BZA 13-67

I SITE PLAN
 REF. SCALE 1" = 50'-0"

REVISIONS	ADDITIONS & ALTERATIONS TO THE RAINSO BAKING COMPANY BUILDING WICHITA KANSAS	JOB NO. 75-05-1
	ENGINEERING DEPARTMENT CAMPBELL TAGGART ASSOCIATED BAKERIES, INC. DALLAS TEXAS	DATE 7-22-68
		BY A

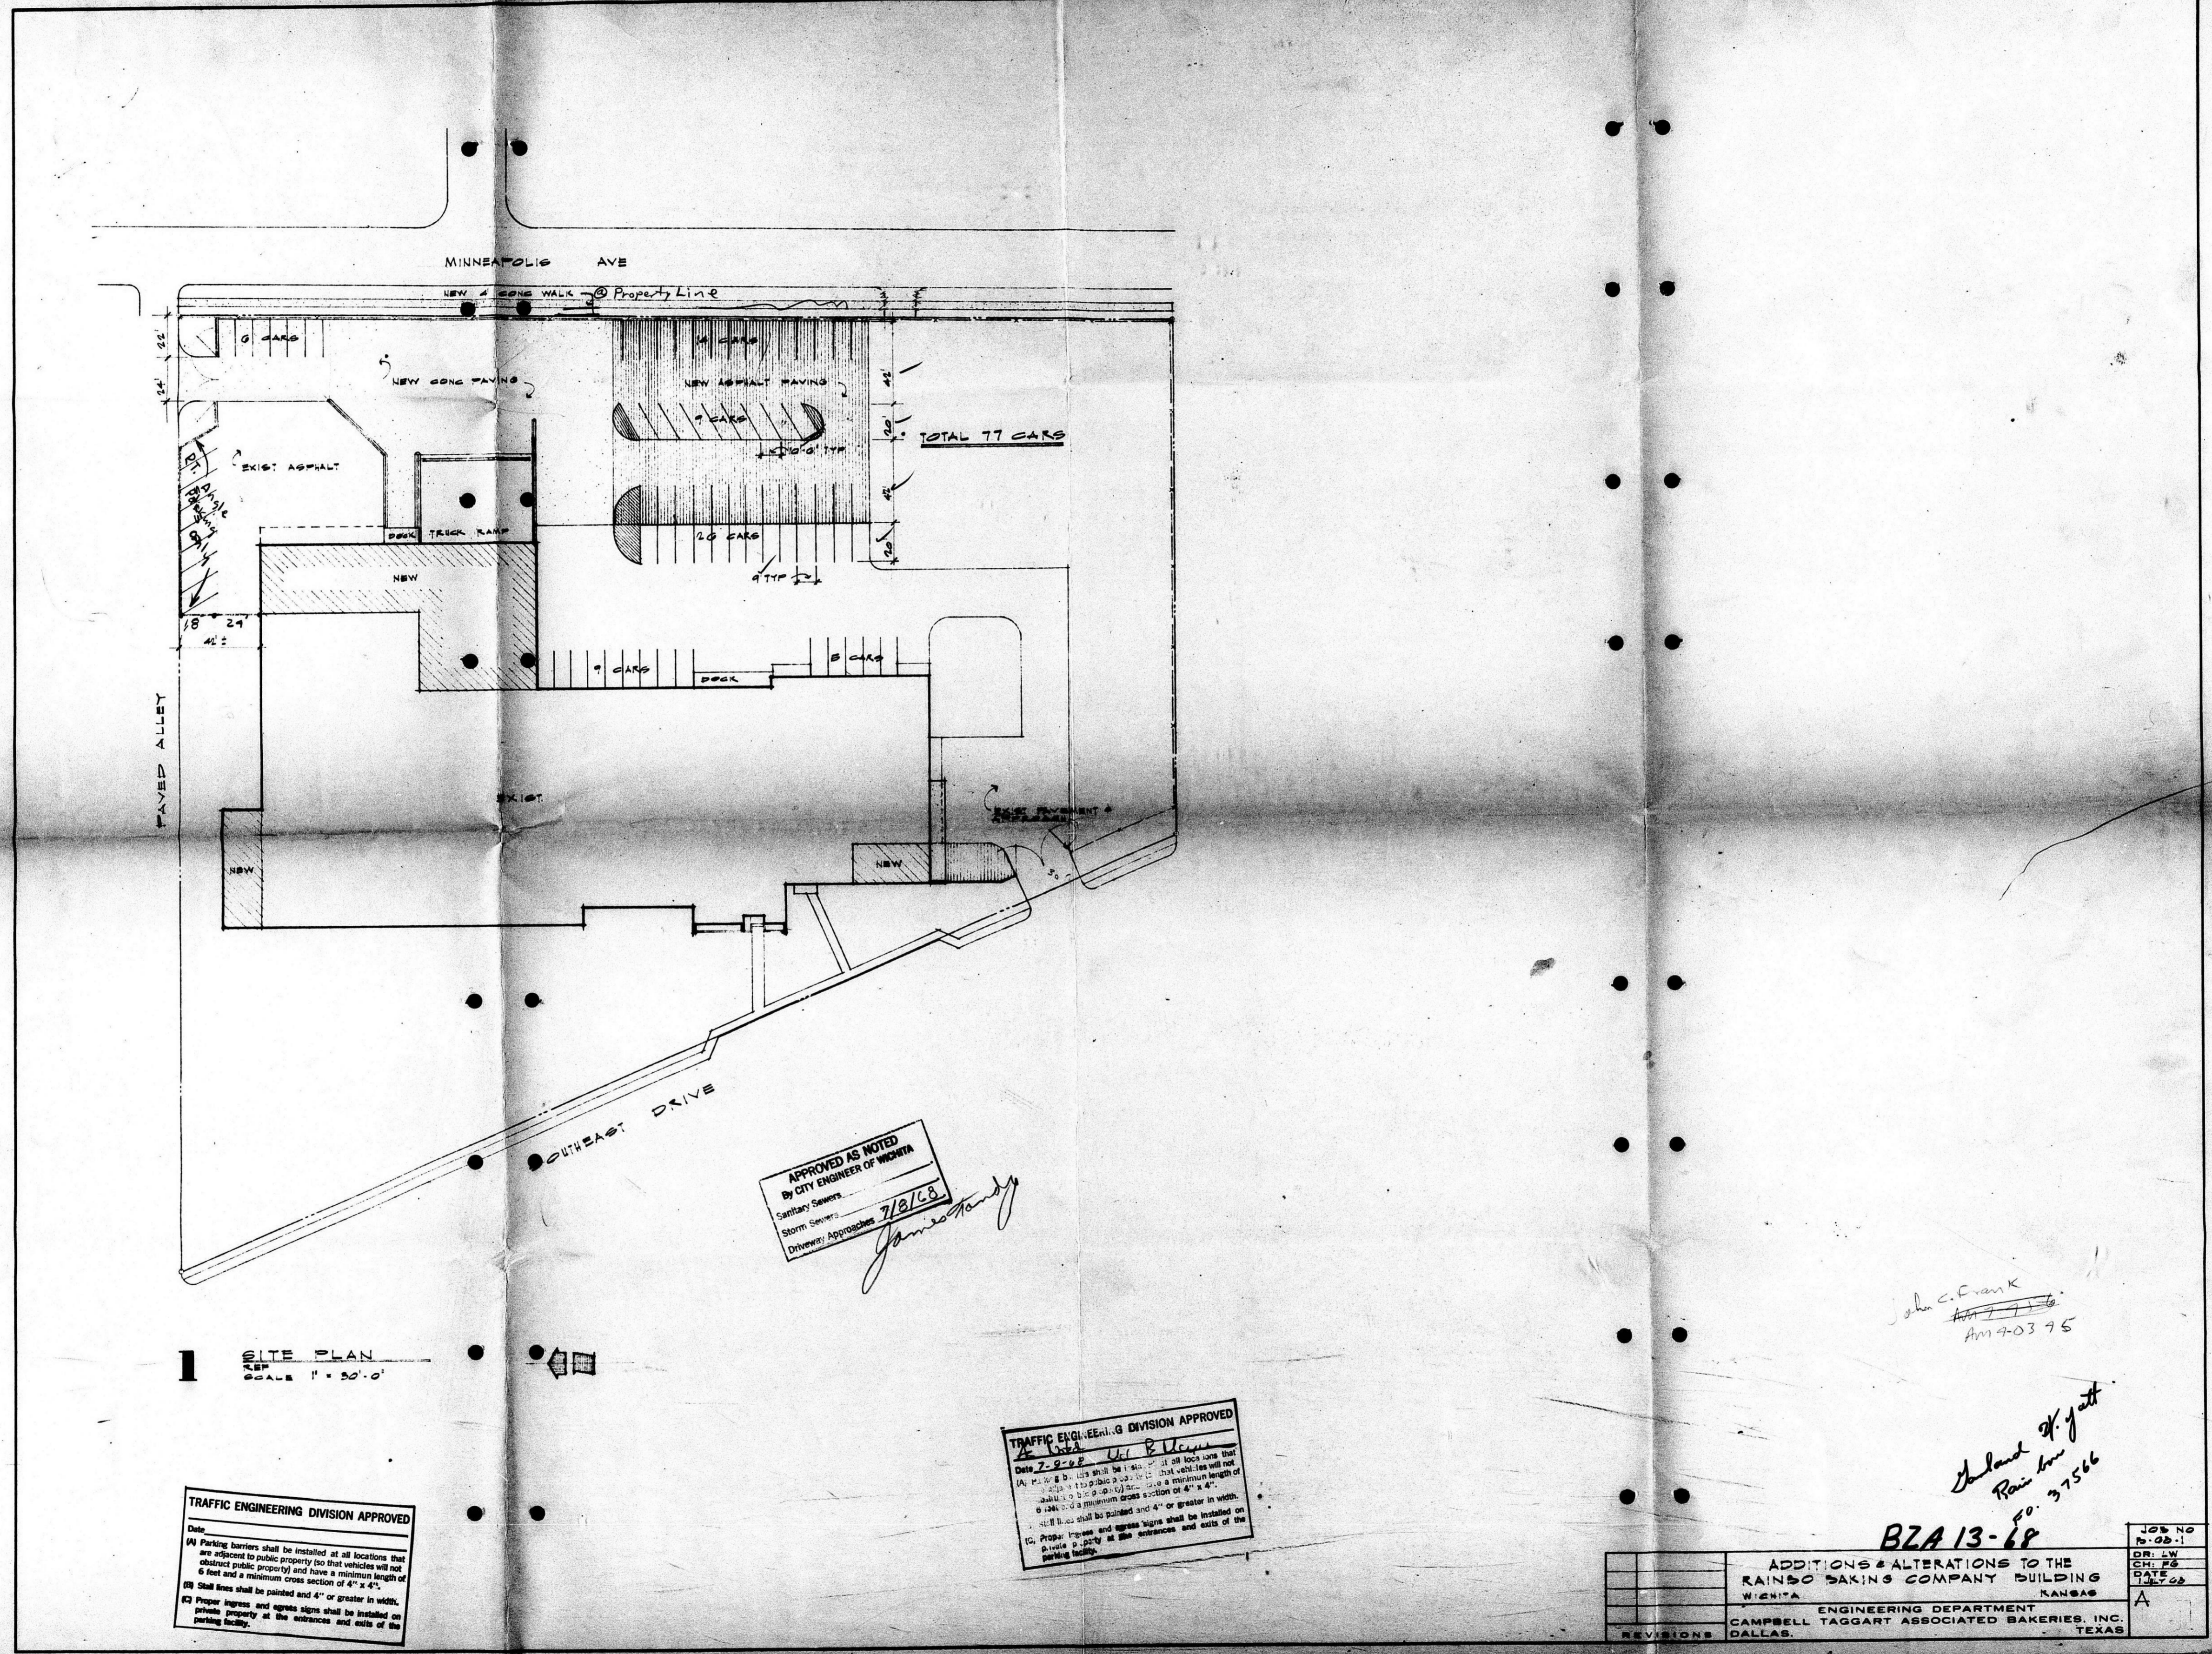
APPROVED AS NOTED
 BY CITY ENGINEER OF WICHITA
 Sanitary Sewers
 Storm Sewers
 Driveway Approaches 7/18/68
James Handy

TRAFFIC ENGINEERING DIVISION APPROVED
 Date
 (A) Parking barriers shall be installed at all locations that are adjacent to public property so that vehicles will not obstruct public property and have a minimum length of 6 feet and a minimum cross section of 4" x 4".
 (B) Street lines shall be painted and 4" or greater in width.
 (C) Proper signs and signs shall be installed on private property at the entrances and exits of the parking facility.

TRAFFIC ENGINEERING DIVISION APPROVED
 Date 7-22-68
 (A) All lock saws that are used to cut through concrete shall be used in a manner that will not damage the concrete surface.
 (B) All lock saws shall be used in a manner that will not damage the concrete surface.
 (C) Proper signs and signs shall be installed on private property at the entrances and exits of the parking facility.
